DEVELOPMENT APPLICATION ASSESSMENT REPORT

Application Number:	DA2023/0185	
Responsible Officer:	Alex Keller	
Land to be developed (Address):	Lot 10 DP 1257419, 25 Loch Street FRESHWATER NSW 2096 Lot 7 DP 14040, 23 Loch Street FRESHWATER NSW 209	
Proposed Development:	Demolition work and alterations and additions to a dwelling house including a swimming pool	
Zoning:	Warringah LEP2011 - Land zoned R2 Low Density Residential	
Development Permissible:	Yes	
Existing Use Rights:	No	
Consent Authority:	Northern Beaches Council	
Land and Environment Court Action:	No	
Owner:	Darren Andrew Holland Tania Brenda Holland	
Applicant:	Bruce Stafford & Associates Pty Ltd	
Application Lodged:	15/03/2023	
Integrated Development:	No	
Designated Development:	No	
State Reporting Category:	Residential - Alterations and additions	
Notified:	21/03/2023 to 04/04/2023	
Advertised:	Not Advertised	
Submissions Received:	1	
Clause 4.6 Variation:	Nil	
Recommendation:	Approval

Image: Height of building and relationship to adjacent land entry area near pool shallow end.

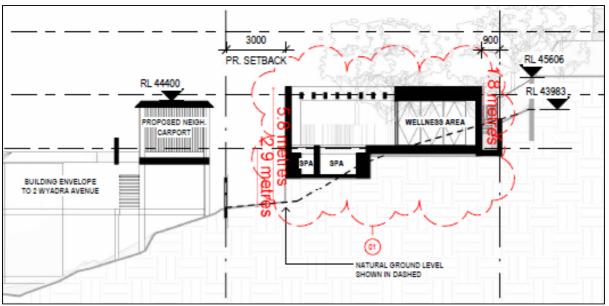
Standard	Requirement	Proposed	% Variation	Complies
Height of Buildings:	8.5m	5.8m to 1.8m (from existing ground) (Spa / Sauna building attached to pool) Pool coping is up to 2.9m above EGL SE corner of pool below EGL	Nil	Yes
